# Work Order ID 112787

Item Name: Crosstube Turning Detail

DRAWING NO. D407-667-145	TITLE CROSSTUBE ASS'Y (407 HIGH FWD)	REV. C	<b>DART AEROSPACE LTD ENGINEERING ORDER</b>		D.E.O. NO. D407-667-145-C-1	SHEET NO. SHEET 1 OF 1	SCALE NTS
DRAWN <i>47</i>	CHECKED <i>ASS</i>	MFG. APPR. <i>AB</i>	APPROVED <i>WD</i>		DE APPR. <i>##</i>		
DATE 11.07.15	DATE 11.07.22	DATE 11.07.22	DATE 11/07/22		DATE 11.07.21

DRAWING NO. D407-667-145	TITLE CROSSTUBE ASS'Y (407 HIGH FWD)	REV. C	DART AEROSPACE LTD ENGINEERING ORDER		D.E.O. NO. D407-667-145-C-2	SHEET NO. SHEET 1 OF 1	SCALE NTS
DRAWN AJS	CHECKED	MFG. APPR.	APPROVED		DE APPR.		
DATE 12.08.02	DATE 12.08.02	DATE 12.08.02	DATE 12.08.02		DATE 12.08.02

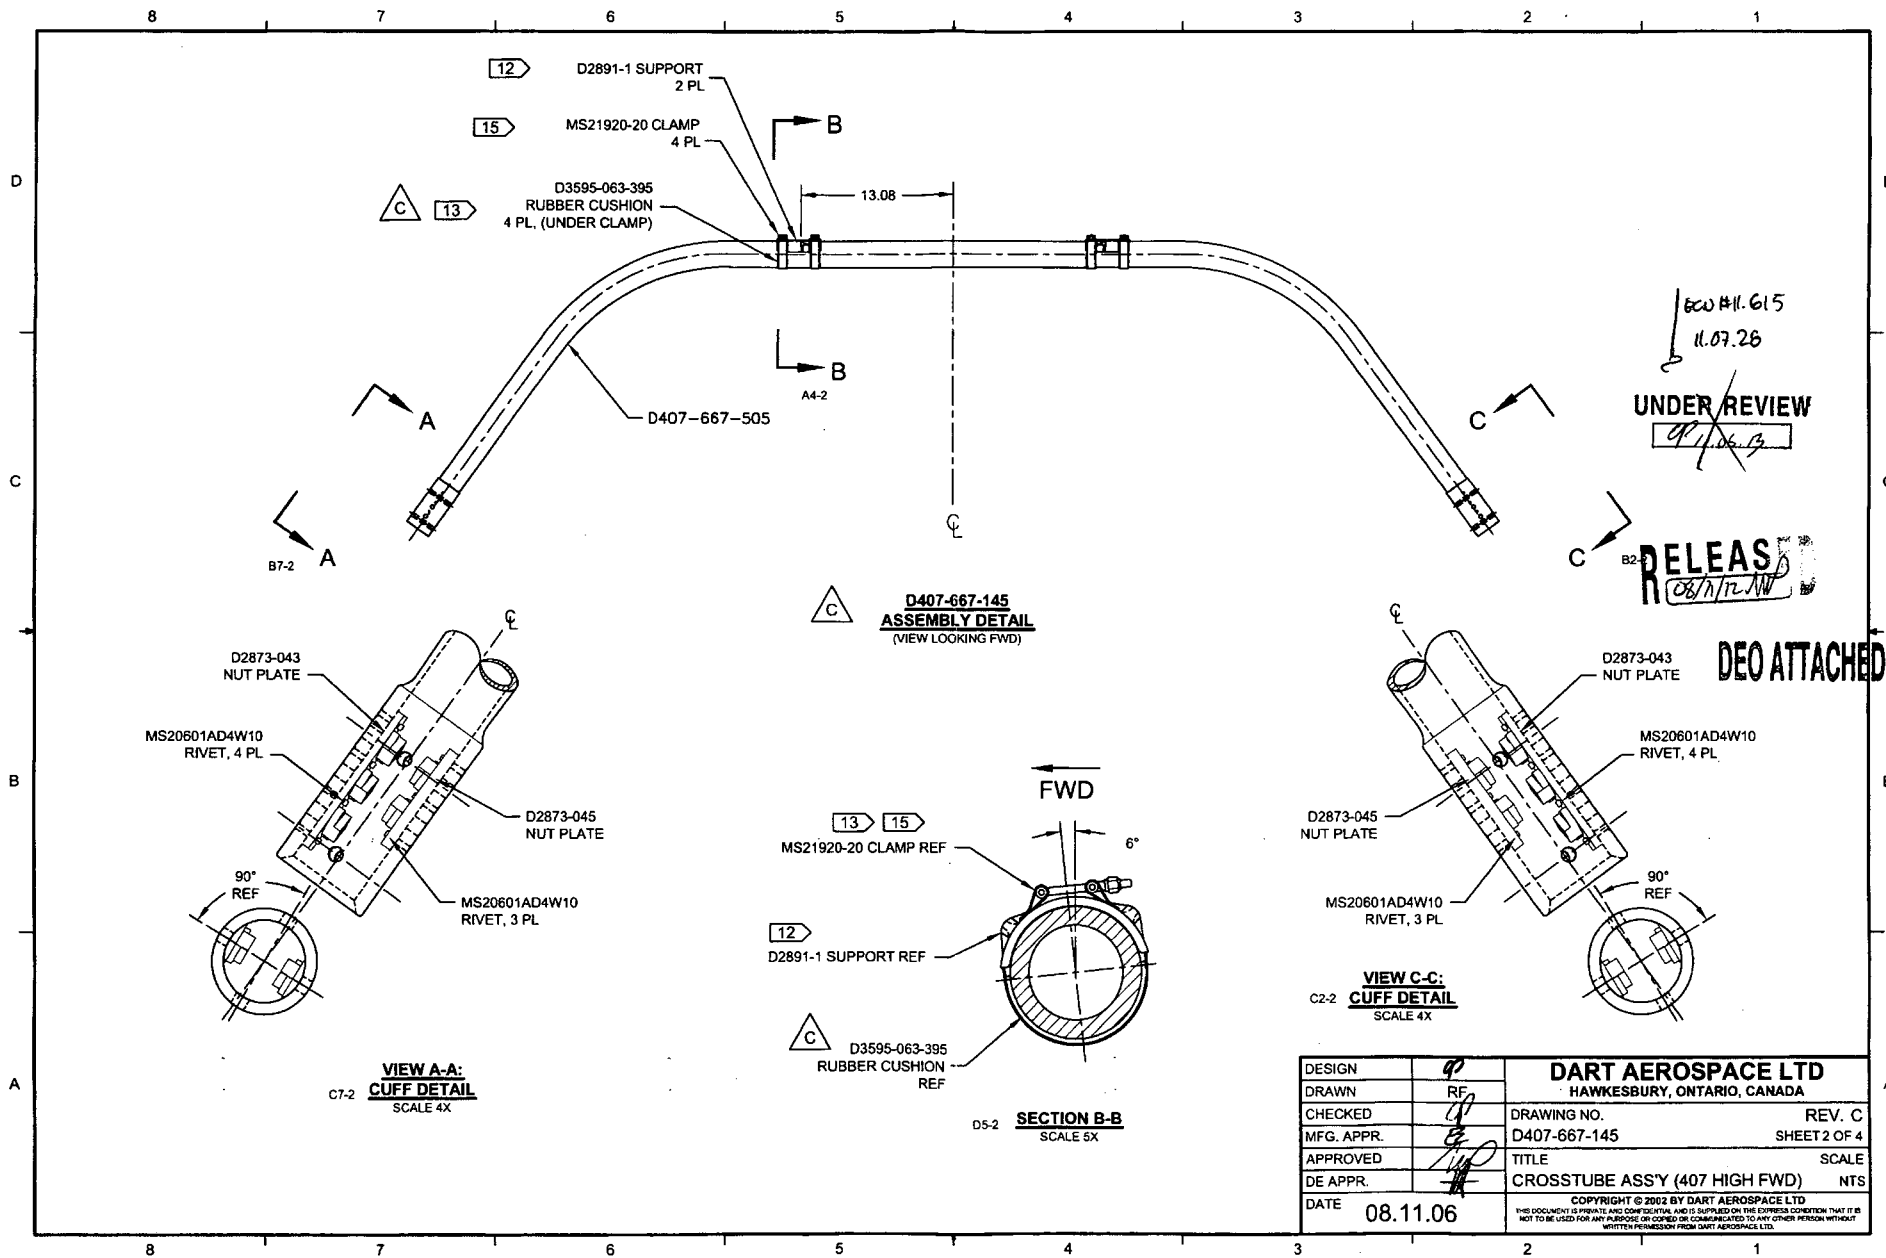
C	REVISE GENERAL NOTES/PART LIST (ZN D7-1); REORGANIZED VIEWS AND REFORMATTED DRAWING TO CURRENT STANDARDS. D3595-063-395 WAS D2856-400-694 (ZN D6-2 & A5-2); REMOVED REF. 7 ADD TOLERANCES (ZN C6-3, C4-3, D2-3); RELOCATED FLAG #6 (ZN A8-3) PER NCR 210; MOVED TURNING DETAIL & UPDATED TOLERANCE TO SHEET 4.	RF	08.11.06
B	ADD HOLES AND NUT PLATES FOR COMPATABILITY WITH BHT/AA SKUDTUBES	PH	05.07.26
A	NEW ISSUE	CP	02.05.08
REV.	DESCRIPTION	BY	DATE
DESIGN	RF	DART AEROSPACE LTD HAWKESBURY, ONTARIO, CANADA	
DRAWN	RF	DRAWING NO. D407-667-145	REV. C SHEET 1 OF 4
CHECKED	RF	TITLE CROSSTUBE ASS'Y (407 HIGH FWD)	SCALE NTS
MFG. APPR.	RF	COPYRIGHT © 2003 BY DART AEROSPACE LTD THIS DOCUMENT IS PRIVATE AND CONFIDENTIAL AND IS SUPPLIED ON THE EXPRESS CONDITION THAT IT IS NOT TO BE USED FOR ANY PURPOSE OR COPIED OR COMMUNICATED TO ANY OTHER PERSON WITHOUT WRITTEN PERMISSION FROM DART AEROSPACE LTD.	
APPROVED	RF	DATE 08.11.06

**DETAIL P**  
BONDING STRAP INSTALLATION 2 PL

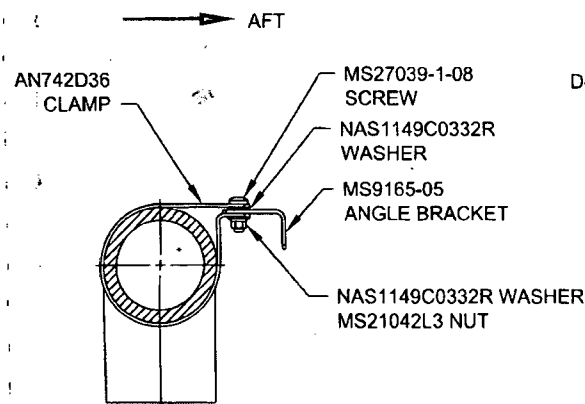
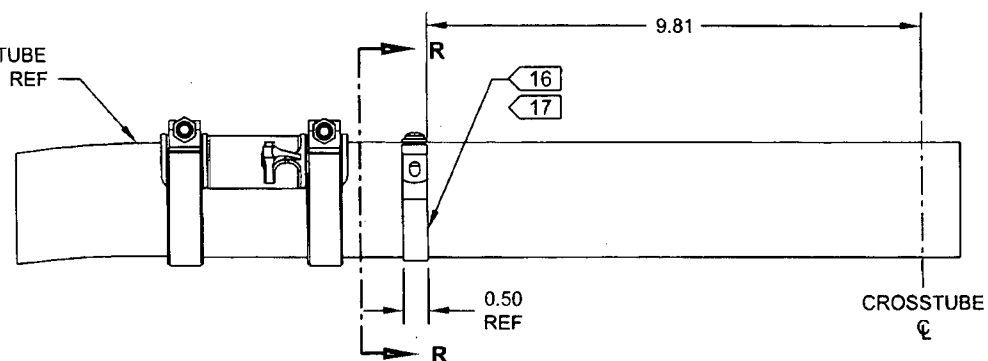
ADD ELECTRICAL GROUNDING STRAP

ITEM	QTY	PART NUMBER	DESCRIPTION
1	X	D407-667-145	CROSSTUBE ASSEMBLY (407 HIGH FWD)
10	2	AN742D36	CLAMP
11	2	MS9165-05	ANGLE BRACKET
12	2	MS21042L3	NUT (OR MS21042-3)
13	2	MS27039-1-08	SCREW
14	4	NAS1149C0332R	WASHER (OR AN960C10L)

- 16) MASK AREA UNDER CLAMP PRIOR TO PAINTING
- 17) SEAL EDGES WHERE AN742D36 CLAMP MEETS WITH THE CROSSTUBE USING SIKAFLEX-241/-291 OR MIL-S-8802 CLASS B2 OR PROSEAL 890 SEALANT
- 18) PERFORM RESISTANCE CHECK TO ENSURE MAX RESISTANCE IS 10 MILLIOHMS
